UNITED STATES OF AMERICA
NUCLEAR REGULATORY COMMISSION

(Comanche Peak Steam Electric Station
Station, Units 1 and 2)

CASE'S PARTIAL ANSWER TO APPLICANTS' STATEMENT OF MATERIAL FACTS AS
TO WHICH THERE IS NO GENUINE ISSUE REGARDING APPLICANTS' USE OF
GENERIC STIFFNESSES INSTEAD OF ACTUAL STIFFNESSES IN PIPING ANALYSIS

AFFIDAVIT OF CASE WITNESSES JACK DOYLE AND MARK WALSH

FIG 1

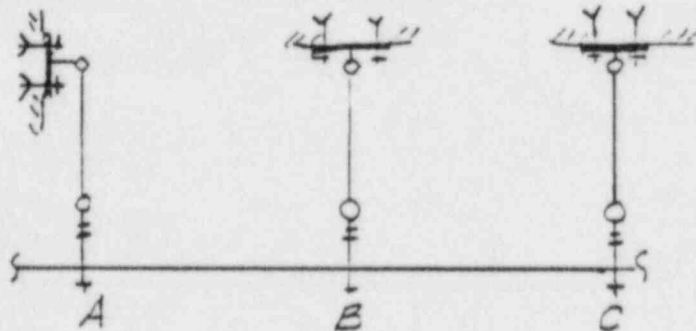
A simple example can demonstrate the consequences of not considering a gap in the base plate. Referring to Figure 1 following, there are three identical (except for their base plate connection) supports labeled A, B, and C, which are supporting a pipe. Because A, B, and C are identical (except for their base plate connection), they

all have an equal amount of stiffness and supports A and C will receive an equal amount of load. For purposes of this example, it will be assumed that the support stiffness is equal to 1,000 lbs. per 1/16" deflection. But support A has a base plate that will transfer the load to the bolts in shear. However, since the base plate was designed as a bearing type connection and slippage is possible, support A will deflect and have a different amount of stiffness now. This stiffness now will be 1,000 lbs. per 3/16" deflection assuming a 1/8" oversize hole in the base plate. The result is the stiffness of support A is 3 times less than that of supports B and C, and with the Applicants' present procedure, this is not accounted for. The results of using incorrect stiffnesses is the subject of Applicants' Motion, but Applicants not using consistent design practices; i.e., bearing type connections for the design of the base plate, friction type connection for the stiffness or deflection calculation.
